Notice of Allowability

10/619,331

RITLAND, PAUL DAVID

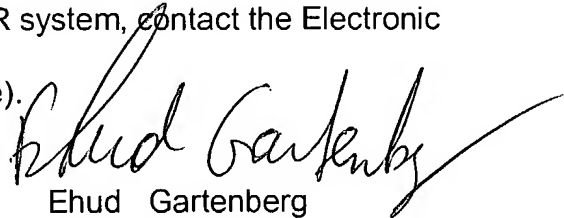
The application has been amended as follows: Figure 2, that was selected by the Examiner to be printed on the face of the patent, has been amended as per the attached drawing, to make the claimed invention immediately recognizable.

2. New corrected drawings (Figures 1 and 2) in compliance with 37 CFR 1.121(d) and 37 CFR 1.84 (l) and (p)(3) are required in this application because Fig. 2 has been amended by the Examiner as per the amendment above, and both Figures 1 and 2 do not comply with 37 CFR 1.84 (l) and (p)(3). Applicant is advised to employ the services of a competent patent draftsman outside the Office, as the U.S. Patent and Trademark Office no longer prepares new drawings. The corrected drawings are required in reply to the Office action to avoid abandonment of the application. The requirement for corrected drawings will not be held in abeyance.
